AGENDA
PLANNING AND ZONING MEETING
Norwalk City Hall, 705 North Ave
Monday, September 25, 2017
5:45 P.M.

**PLANNING & ZONING COMMISSION
AGENDA STATEMENT**

ITEM TITLE: Request from Sunset Crest LLC to approve a site plan for the Sunset Crest site at 1329 Sunset Drive

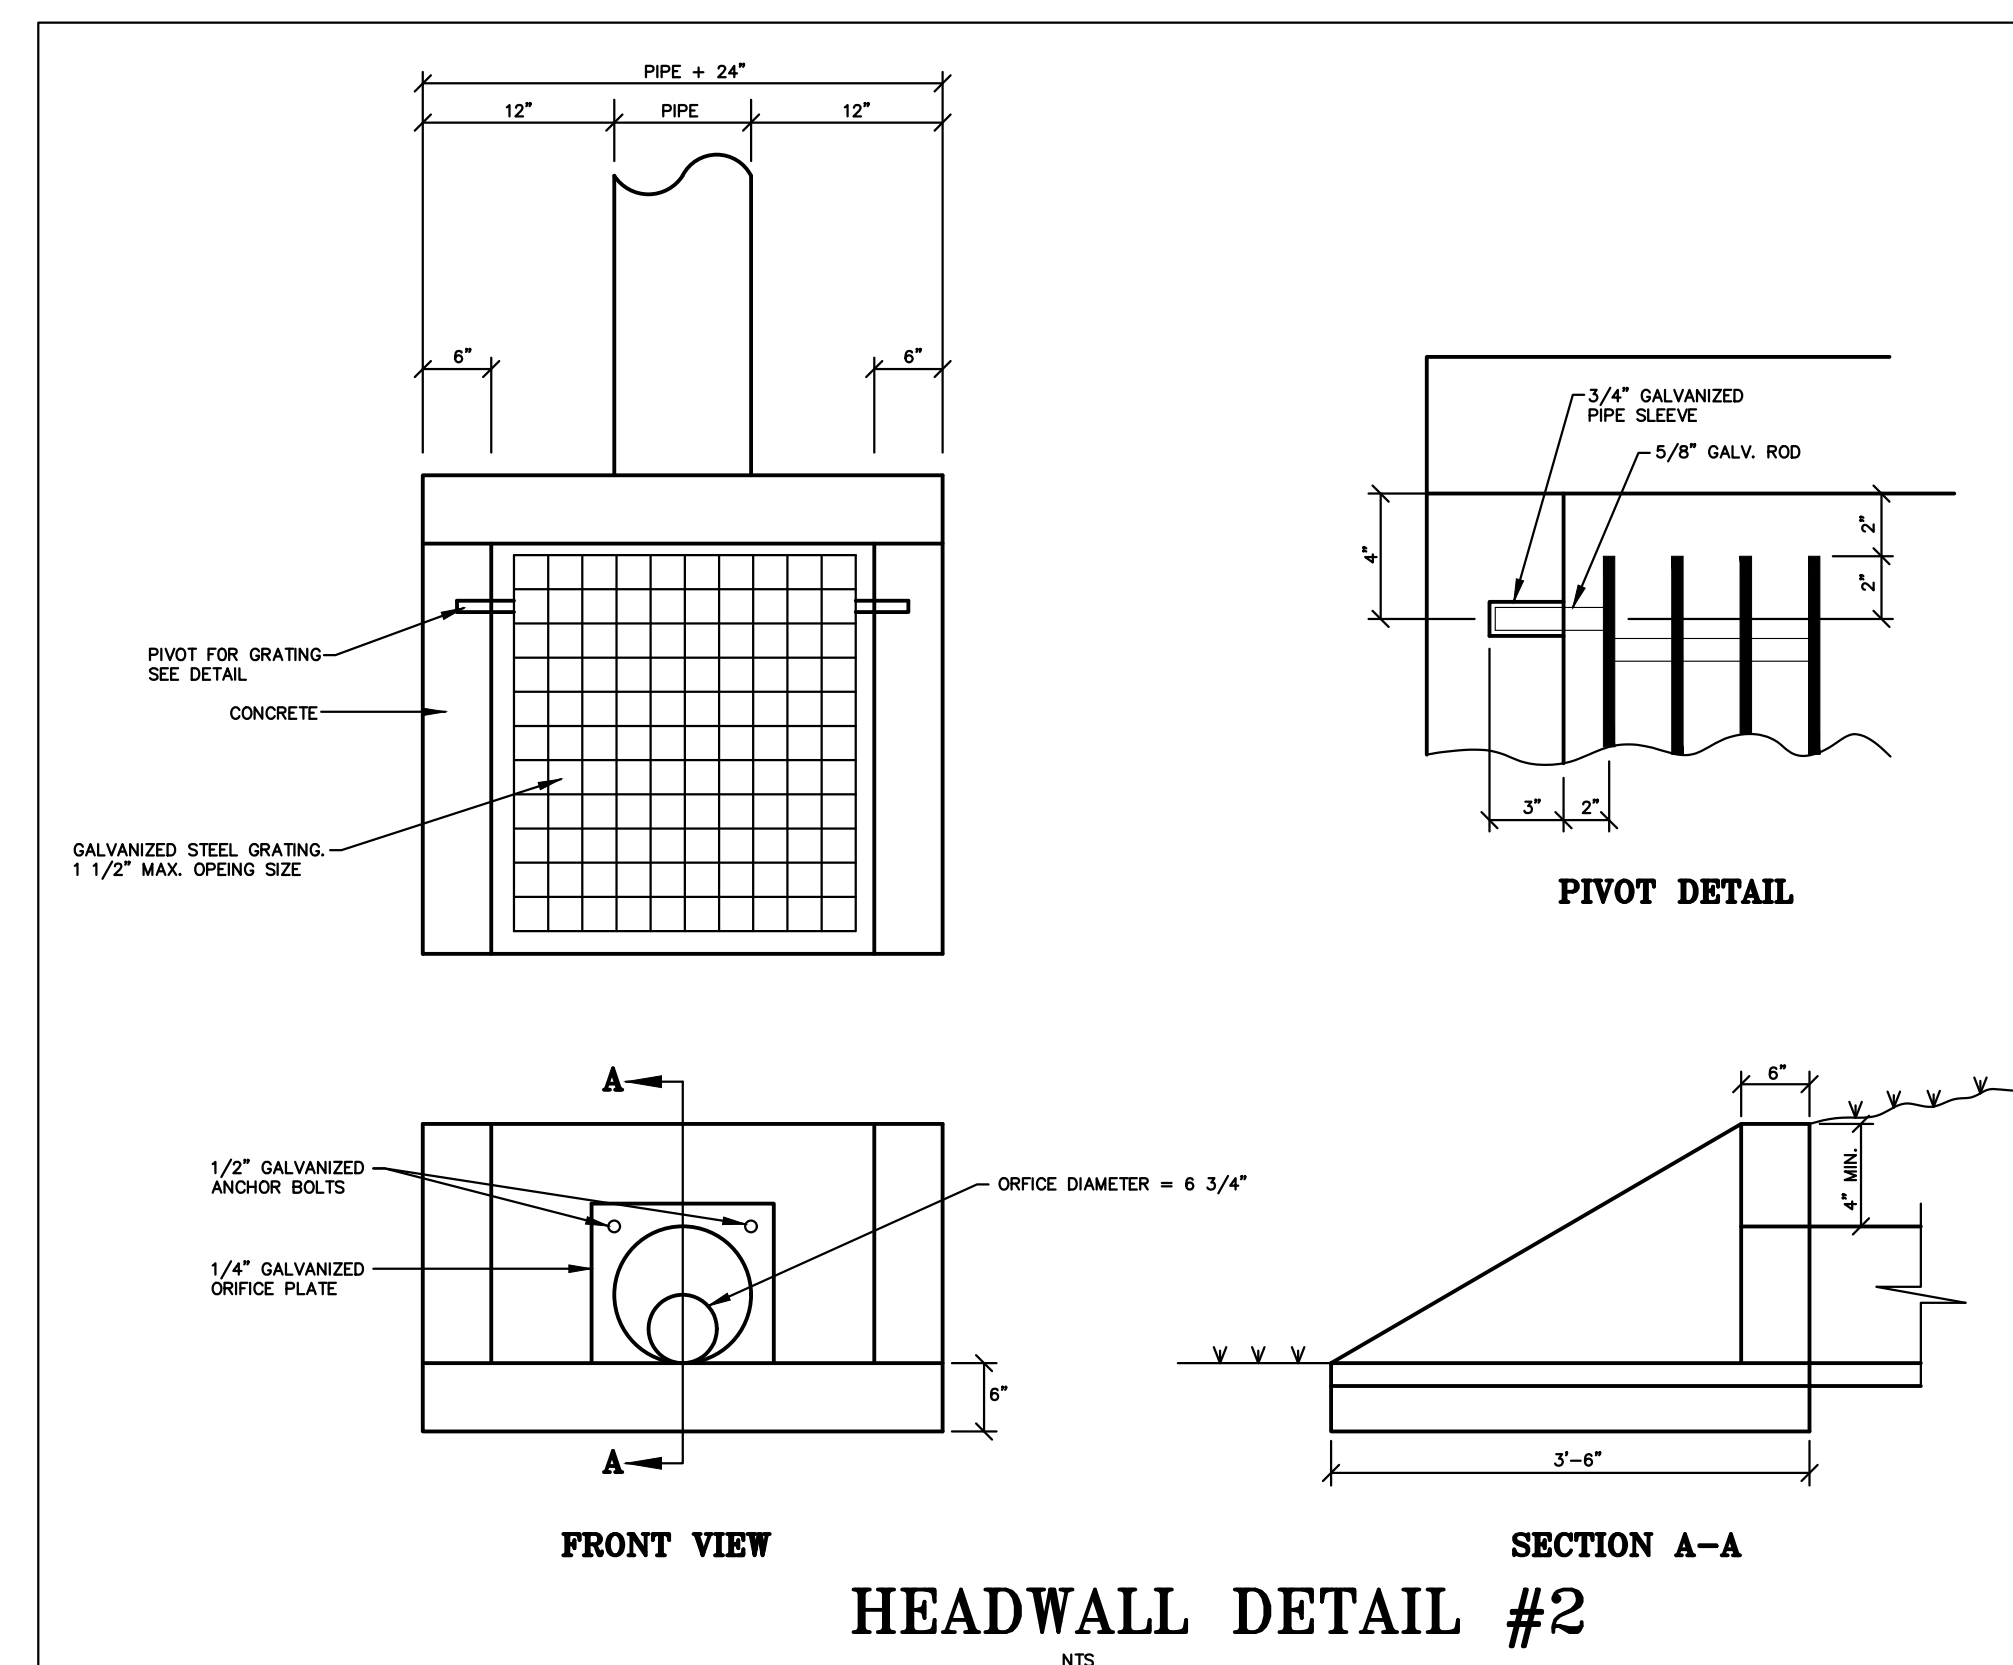
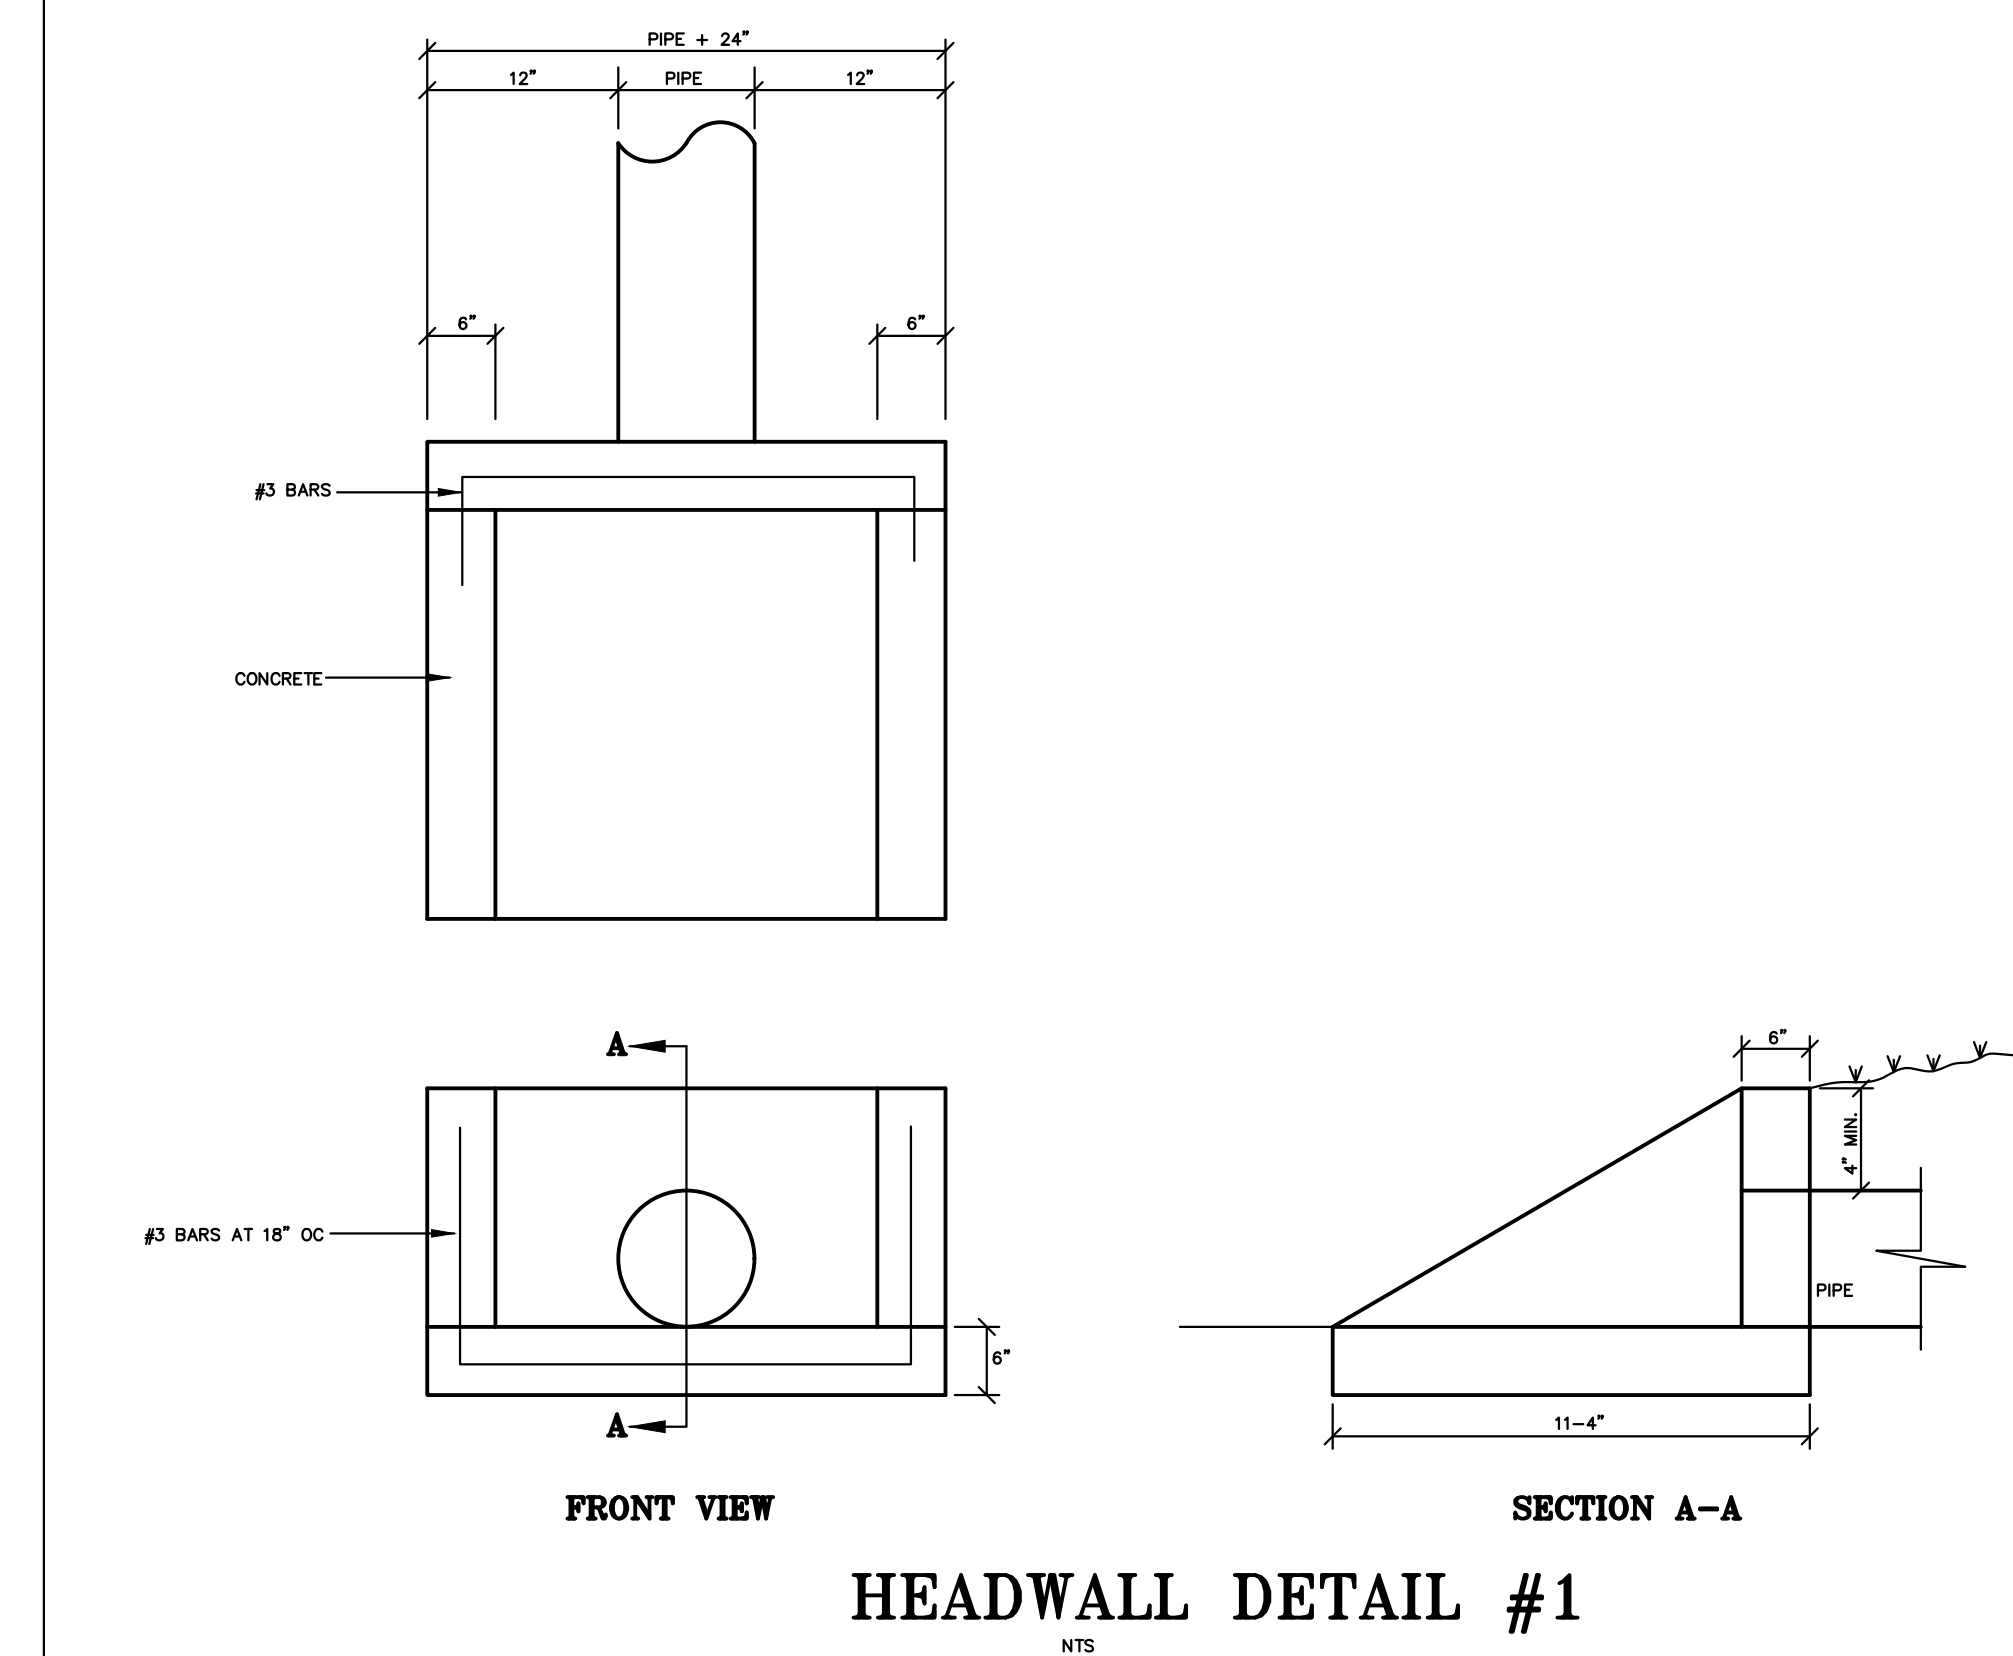
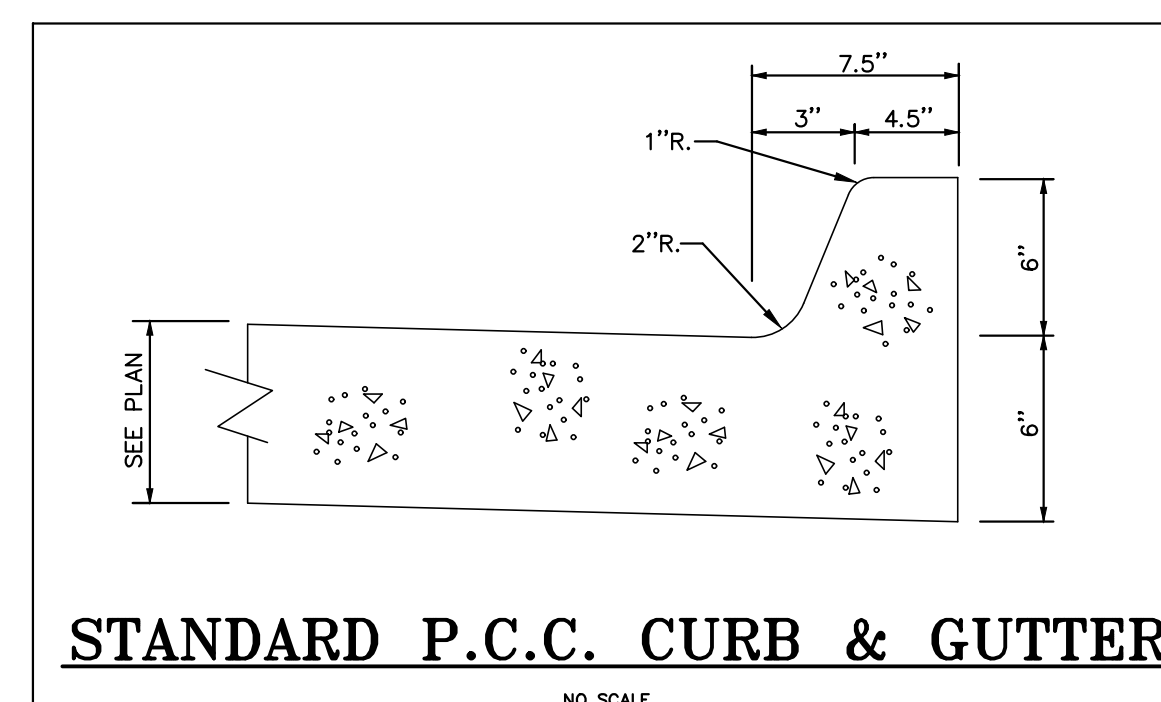
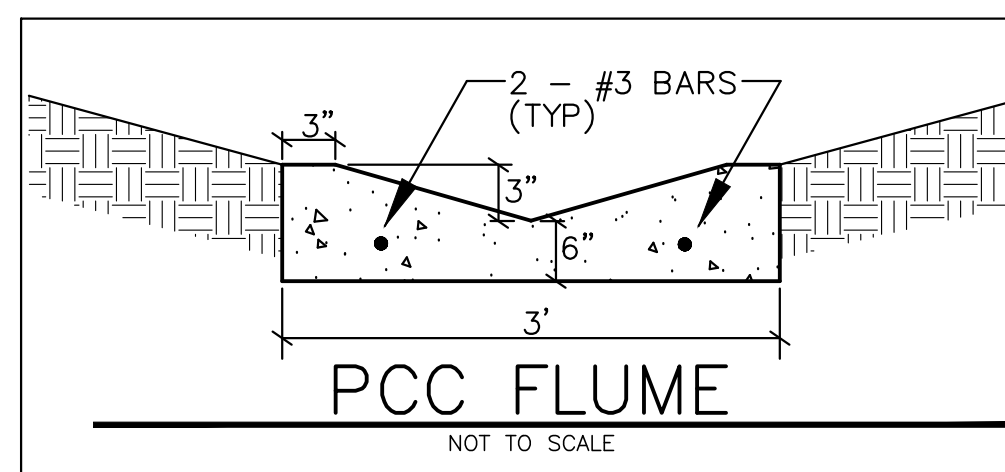
The façade of the building is composed of glass, Nichiha fiber cement panels, PAC-CLAD aluminum metal panels, and PAC-CLAD corrugated wall panels.

The City's architectural standards require that buildings in the C-2 district be composed of 75% class 1 or class 2 materials on the street facing façade; no more than 25% class 3 materials, with any class 4 materials being no more than 10% of the façade.

The City standards are written in a manner that encourages glass and masonry buildings. The developer is proposing a building that utilizes various architectural metal panels in lieu of the masonry products typically required by the code. The standards do not clearly classify this material type into the four classifications. The City needs to determine if these materials meet the intent of the ordinance. The developer has stated that the material is powder-coated, which requires less maintenance than painting, and that the manufacturer provides a 60 year warranty on the material. The developer and the architect are also prepared to further discuss the material at the Commission meeting.
